City of Fredericksburg

Planning and Zoning Meeting Agenda
Wednesday, July 2, 2025 ~ 5:30 PM
New City Hall at East Campus
2818 E. U.S. Hwy. 290
Fredericksburg, Texas 78624

PLANNING AND ZONING COMMISSION
AGENDA MEMO

SITE PLAN

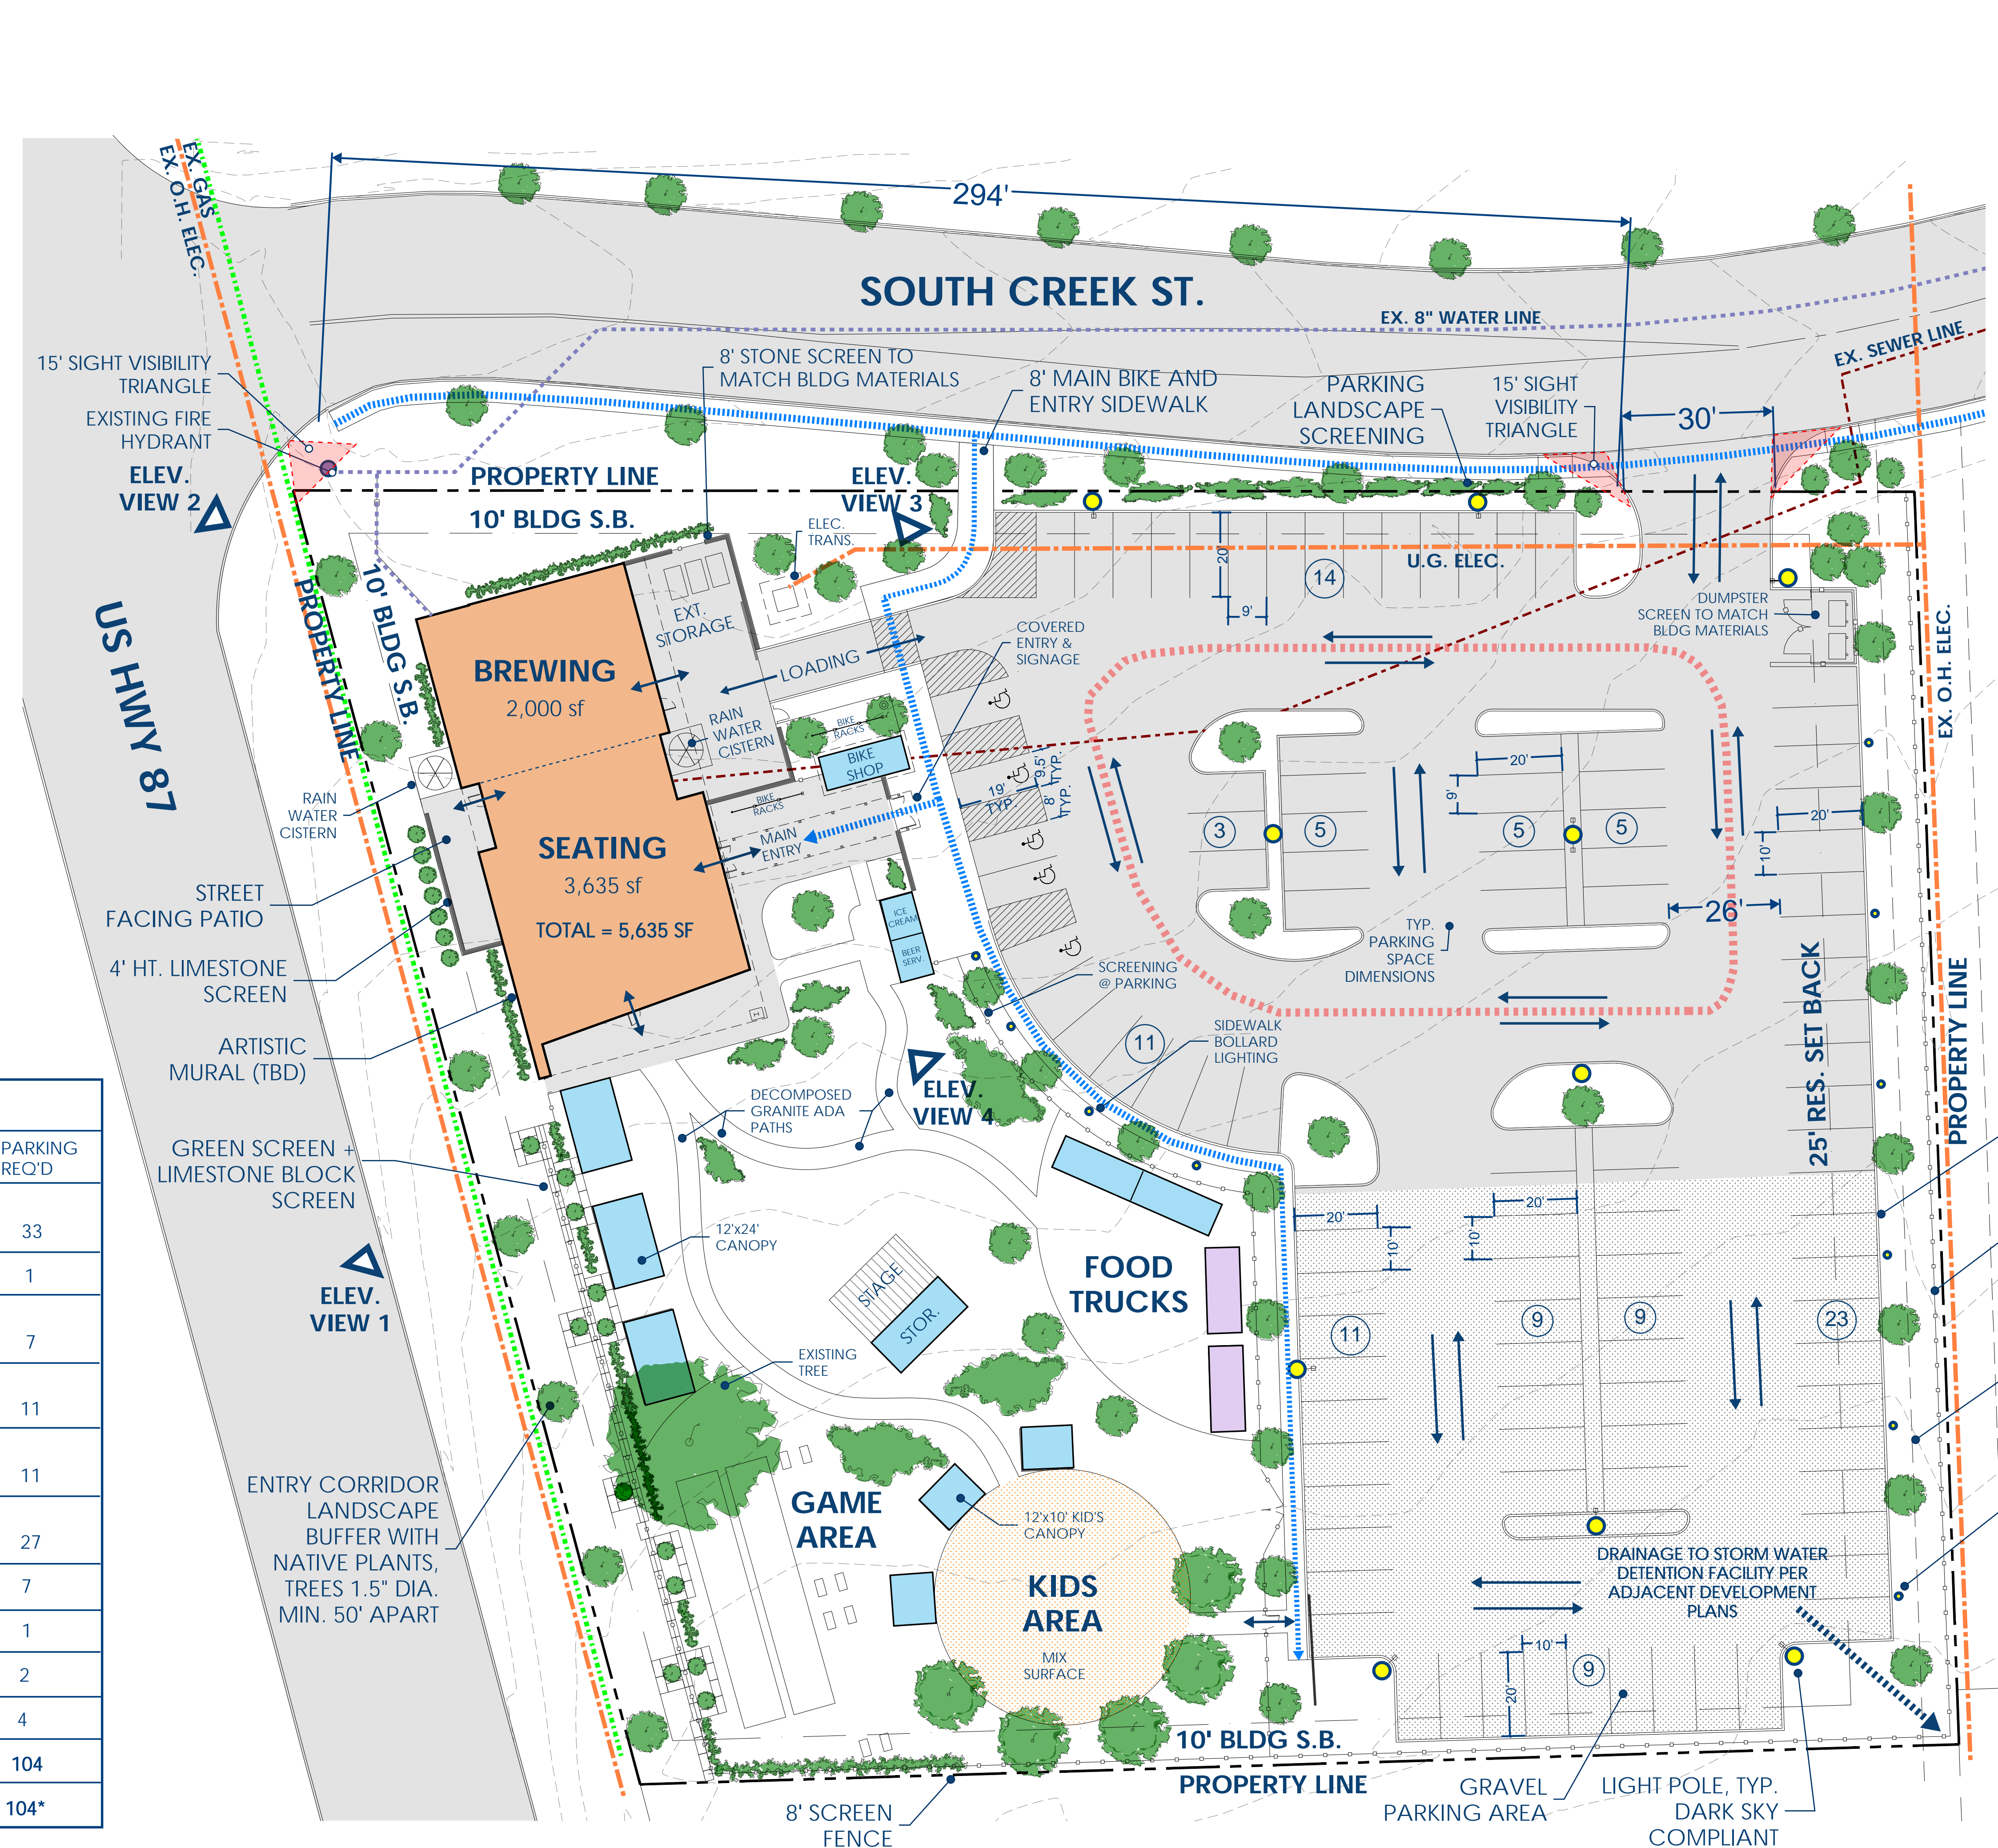
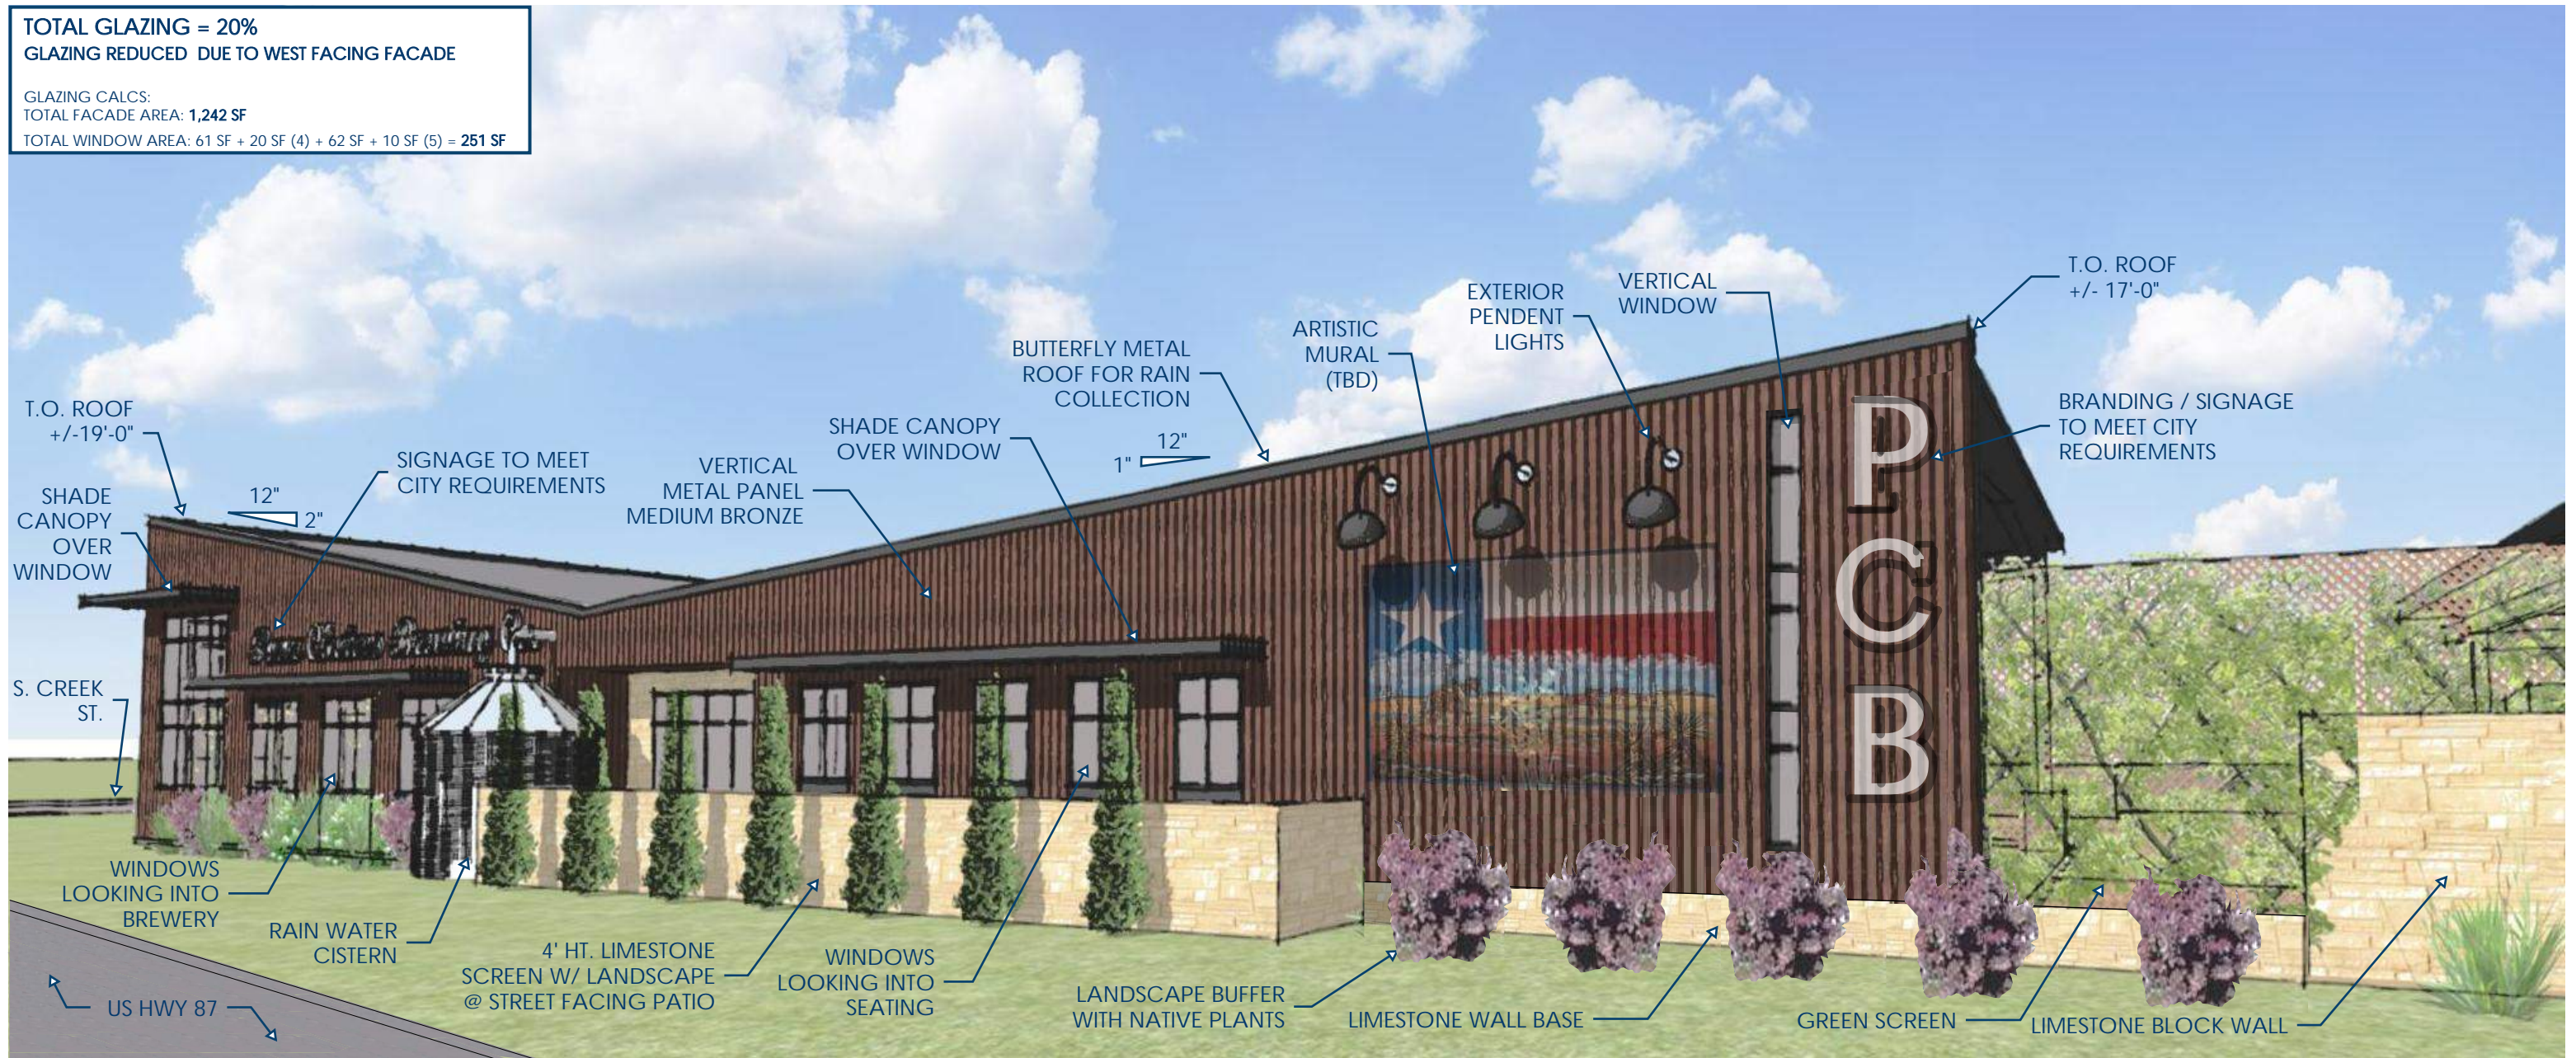
- Provide a revised site plan to include the following:
 - Updated Zoning Summary – Zoning at time of CUP will be M1, not C2.
 - [Sec. 3.310. - M-1: LIGHT MANUFACTURING. | Code of Ordinances | Fredericksburg, TX | Municode Library](#)

- Provide proposed Building Height. [Sec. 3.310](#)
 - Update parking requirements based on Sec. 7.863 – Light Manufacturing – which requires an interpretation from the Development Services Director, who recommends parking the Brew area at 1 per 400 and the Serving Area (seating) at 1 per 3 seats (same as Cocktail Lounge).

- Staff does not recommend the Stage or Outdoor Amplified Music per [Sec. 7.131](#) & [Sec. 5.460](#).
 - Dimension ADA spaces and show compliance with ADA. [Sec. 7.131](#)

- Landscaping and Screening Plan per [Sec. 7.920](#) & [Sec. 7.940](#) & [Sec. 7.980](#)
- Provide Bicycle Parking for the development [Sec. 7.131](#).

Response: The site plan has been updated to reflect M1 zoning, and all zoning specifications now correspond accordingly.

Response: All impervious cover calculations have been updated to include outbuildings, canopies, and hardscape pathways. Building coverage includes all roofed structures.

Response: All proposed buildings—including covered seating, stage, storage, and covered entry—have been accounted for. References to any potential future buildings have been removed. However, we appreciate staff’s insights and have incorporated flexibility into the layout to allow for potential future structures that could comply with Entry Corridor standards.

Response: Proposed building heights are provided on the Site Plan Sheet under ‘Building Information’ and noted on Elevation #1 (US87S-facing).
